**Review of the Black Rock and Wymer Dam Sites Geology as Presented in the
Draft Planning Report/Environmental Impact Statement
Yakima River Basin Water Storage Feasibility Study**

Harold Magistrale, Ph.D., J.D.

Figure 1. Faults and folds (red lines) in south-central Washington State. Note the proximity of major fault and fold structures to the proposed Black Rock and Wymer dam sites (indicated by black bars). Map is taken from Lidke, *et al.* (2003).

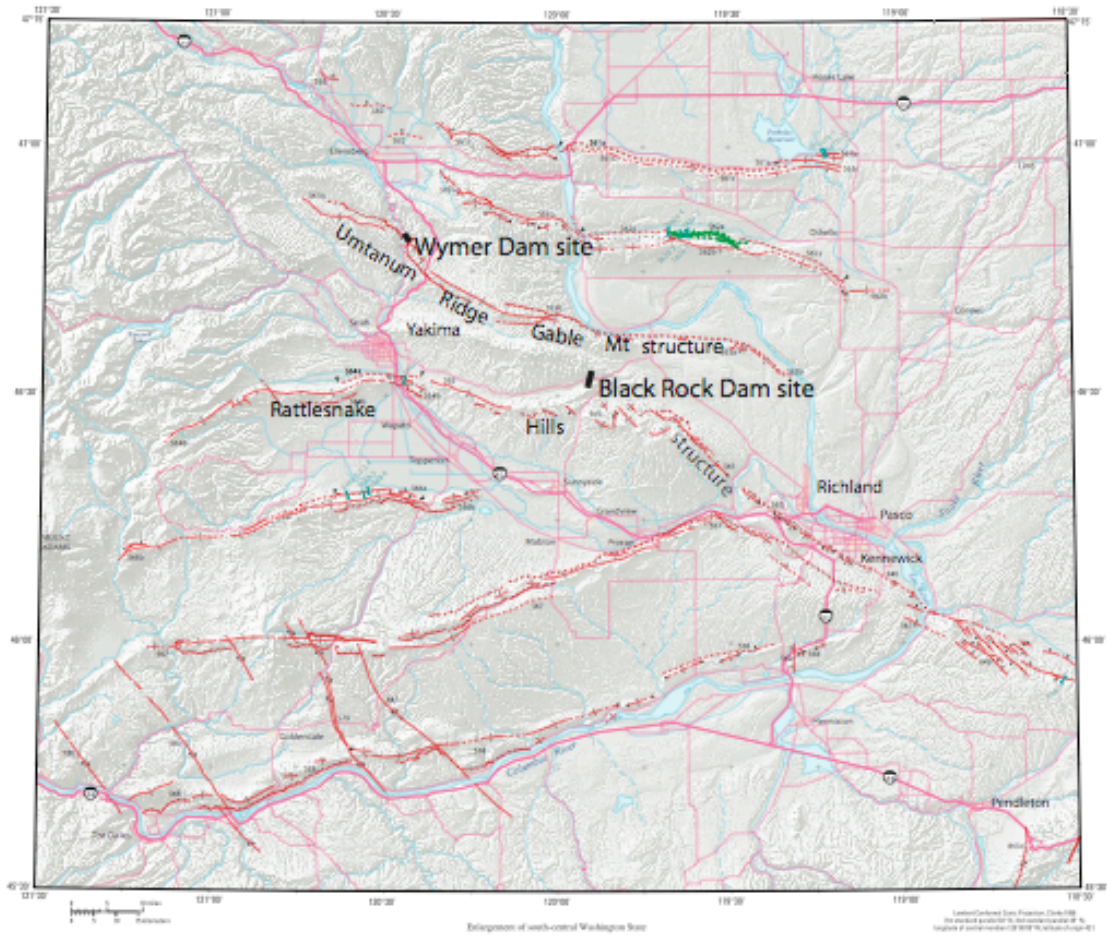
A cursory examination of the USGS fault map (Figure 1) shows that the Umtanum Ridge – Gable Mountain Structure, a 200 km long fault and fold system, runs only a kilometer to the west of the dam site, just across Highway 821 (Lidke *et al.*, 2003). The PSHA study included this fault system in its assessment of the Black Rock Valley site PHA. The failure of the draft EIS here to note the proximity of this major fault to the Wymer dam site renders the draft EIS inadequate, and does not build confidence in the seismic hazard evaluation process.

The most common orientation of the faults and folds in the Yakima Fold Belt is east–west, but the Umtanum Ridge – Gable Mountain Structure strikes northwest–southeast near the Wymer dam site (Figure 1; Reidel *et al.*, 2003). This part of the fault structure may be associated with the Olympic-Wallowa lineament, an alignment of faults and folds that may represent a fundamental, crustal scale discontinuity (*e.g.*, Reidel *et al.*, 1994). The different orientation of the Umtanum Ridge – Gable Mountain Structure near the dam site, and its possible association with the Olympic-Wallowa lineament, suggests the fault near the dam site may respond to the regional stress differently than the faults near the Black Rock Valley site (*e.g.*, with different recurrence times or different size earthquakes). This suggests that an independent seismotectonic analysis of the Wymer dam site must be performed before the EIS can be considered adequate.
